# RSH ENGINEERING, INC.

**PRE-POUR #2 INSPECTION REPORT**

**INSP#: S08156**

**Client: John Doe**

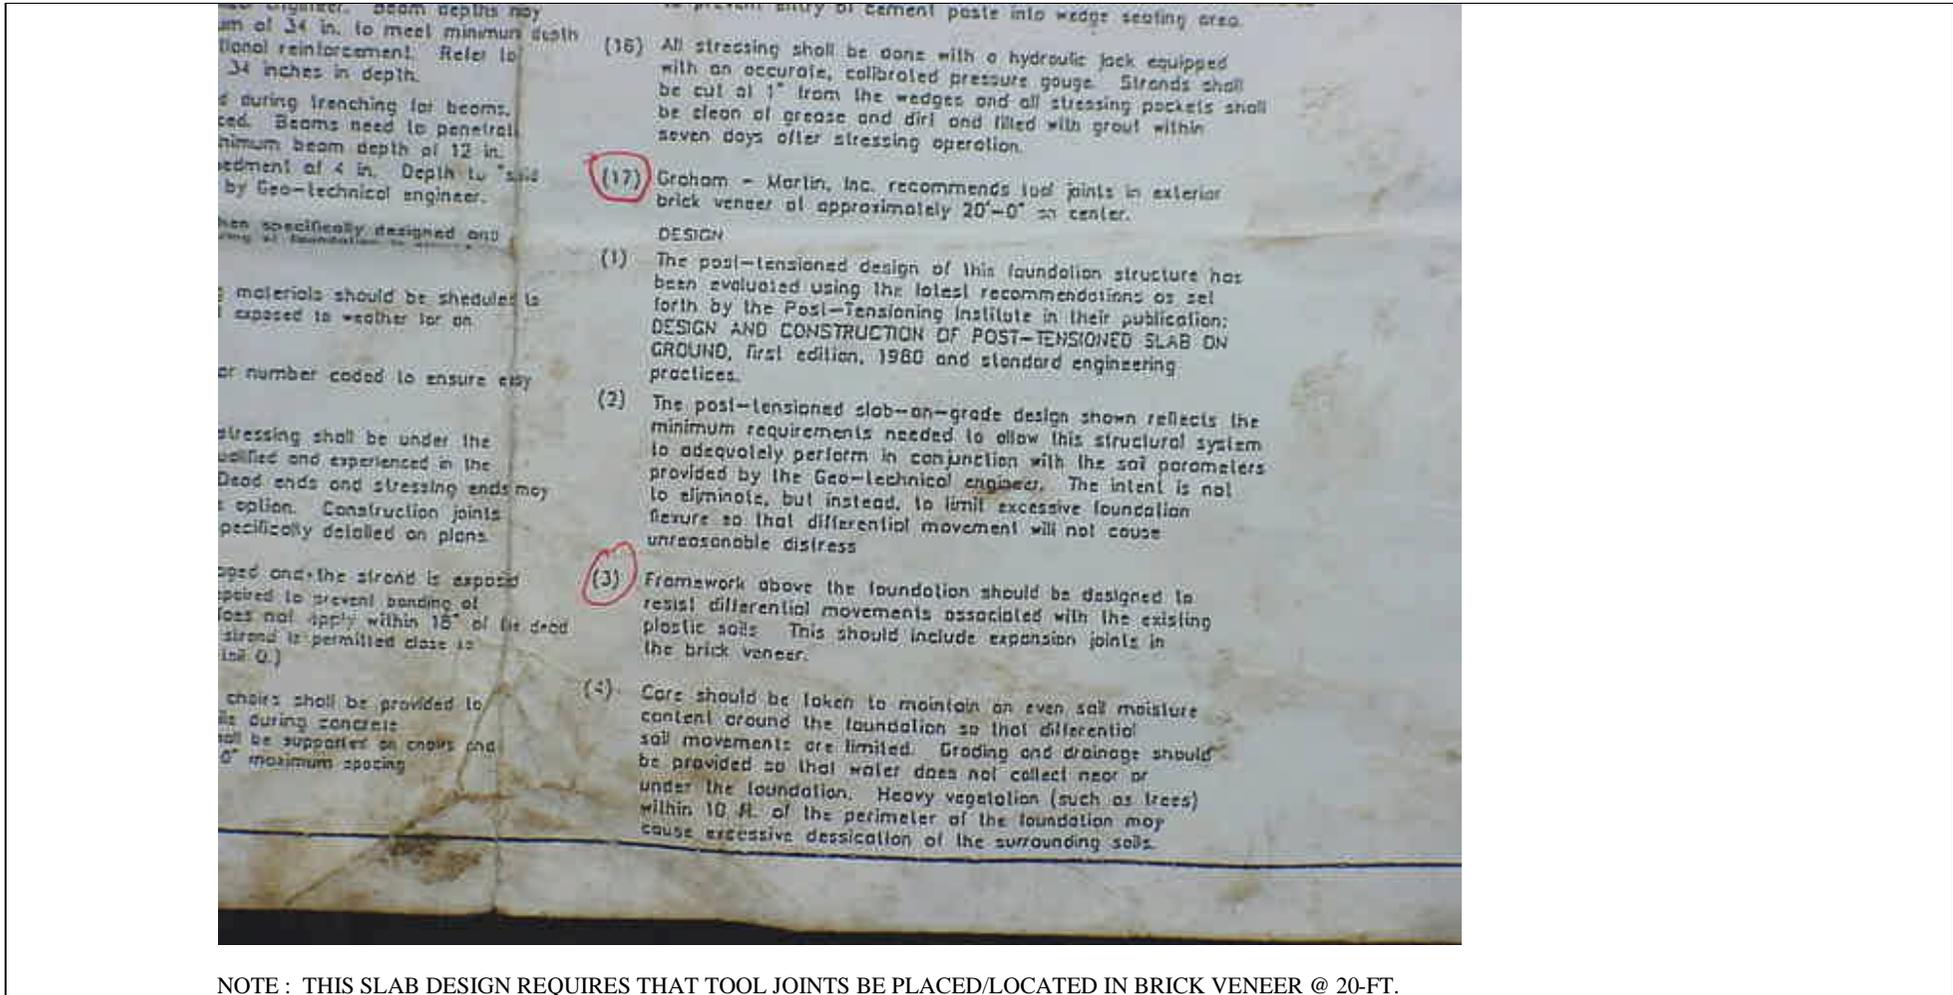
NOTE : THIS SLAB DESIGN REQUIRES THAT TOOL JOINTS BE PLACED/LOCATED IN BRICK VENEER @ 20-FT.

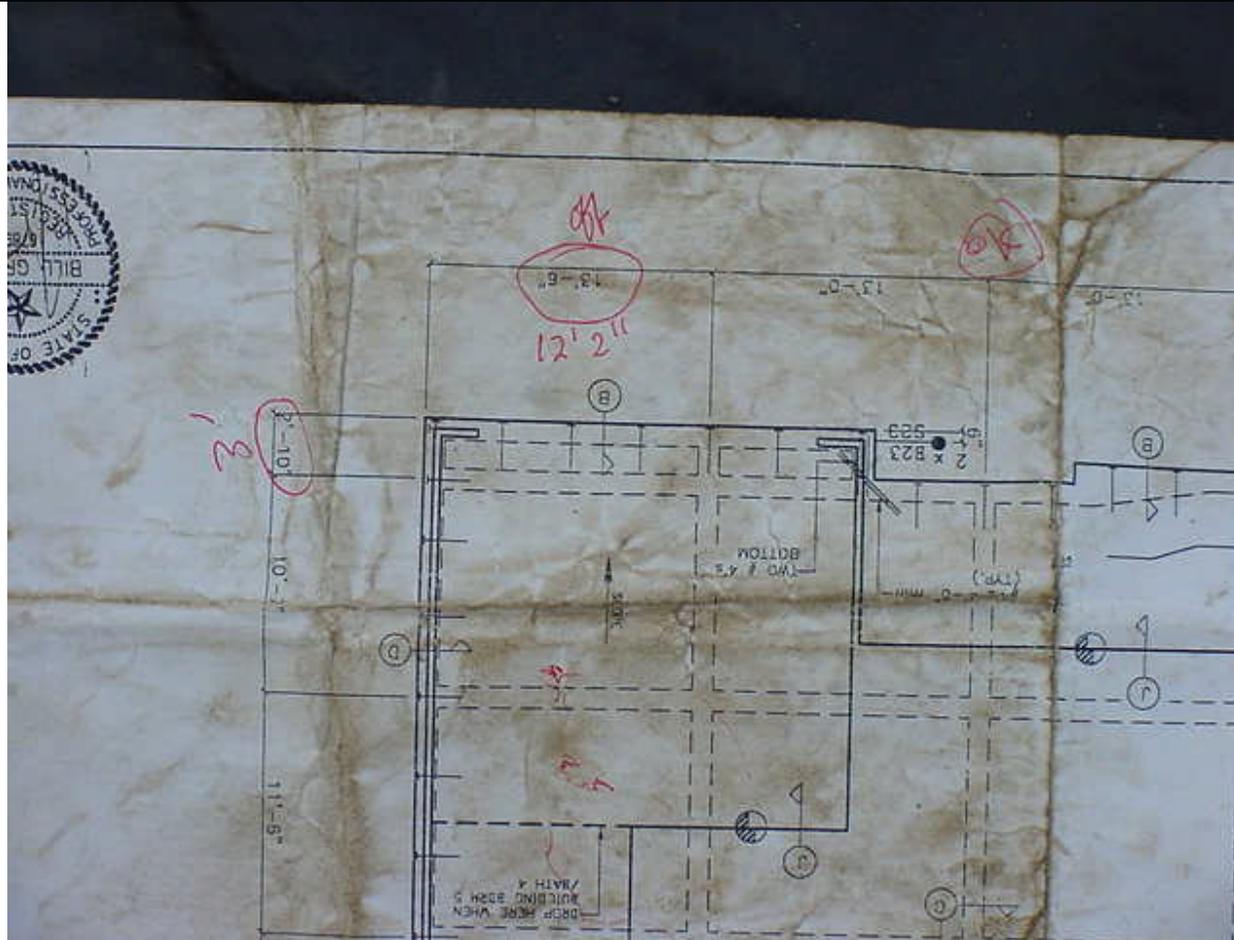
THE TRENCH PER DRAWING SHOULD BE LOCATED AT 13-FEET 6-INCHES. THE TRENCH WAS LOCATED AT 12-FEET 2 INCHES FROM END. HAVE THE FOUNDATION ENGINEER EVALUATE THIS AND RECOMMEND REPAIR. RSH ENGINEERING, INC. RECOMMENDS THAT THE TRENCH BE WIDENED TO MEET THE REQUIREMENTS.
